Product Change Notification

Bourns® Model SRP1770TA Series Shielded Power Inductors

Change to Product Dimension

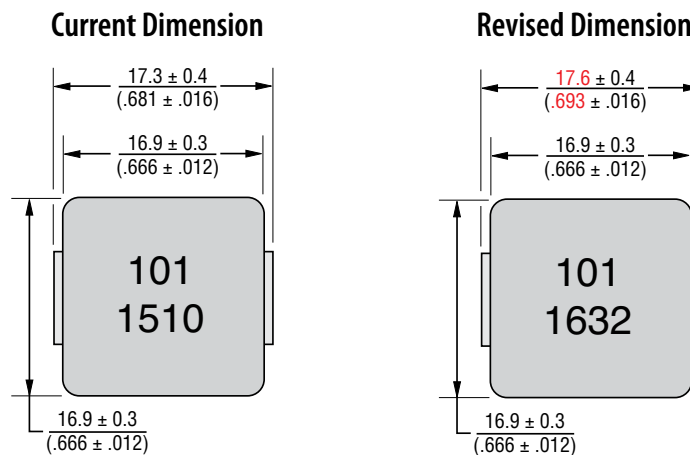
Due to the operational limitation of our equipment, the bending radius of the solder terminal for the [Model SRP1770TA Series Shielded Power Inductors](#) cannot be formed as small as originally expected on some assembly lines. As a result, the length of the inductor will be revised from 17.3 ± 0.4 mm to 17.6 ± 0.4 mm. While there is a change to the products' fit, the products' form, function, quality and reliability will remain the same.
